PIC16F716 Silicon Errata and Data Sheet Clarification

The PIC16F716 device that you have received conforms functionally to the current Device Data Sheet (DS41206B), except for the anomalies described in this document.

Data Sheet Clarifications

FIGURE 9-3: RC OSCILLATOR MODE

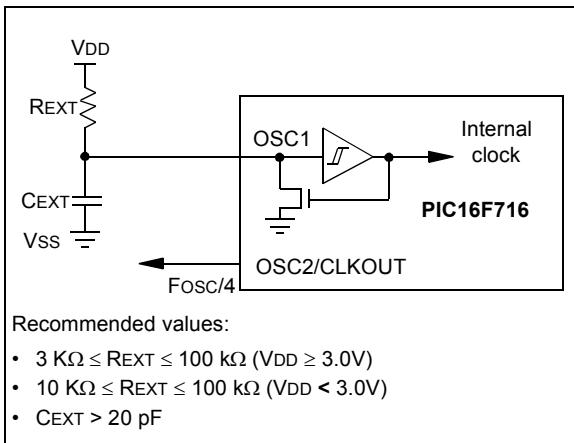
1. Module: Oscillator Configuration

In Figure 9-3, revise the second line of recommended values as follows:

$$10 \text{ k}\Omega \leq \text{REXT} \leq 100 \text{ k}\Omega \text{ (VDD} < 3.0\text{V)}$$
